Project: Wake Forest Elementary School Retaining Wall Replacement
(WCPSS # 862-0710/0584)
Dewberry Project 50167130

RE: Addendum No. 2

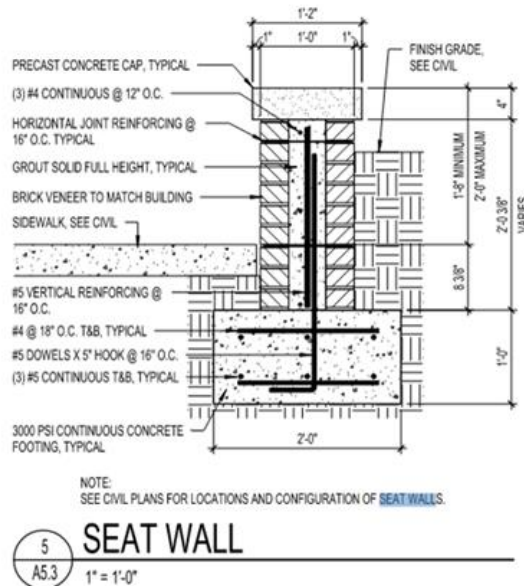
- The trees located near the gas meter and transformer may be cut flush to the proposed grade to avoid damage to any of the surrounding existing utilities in lieu of being completely removed. Also, the Contractor to remove the existing stump as shown below so it is flush with the proposed grade and does not protrude thru the new mulch bed. Refer to revised sheet C101 for additional information. (item #27J from Addenda)
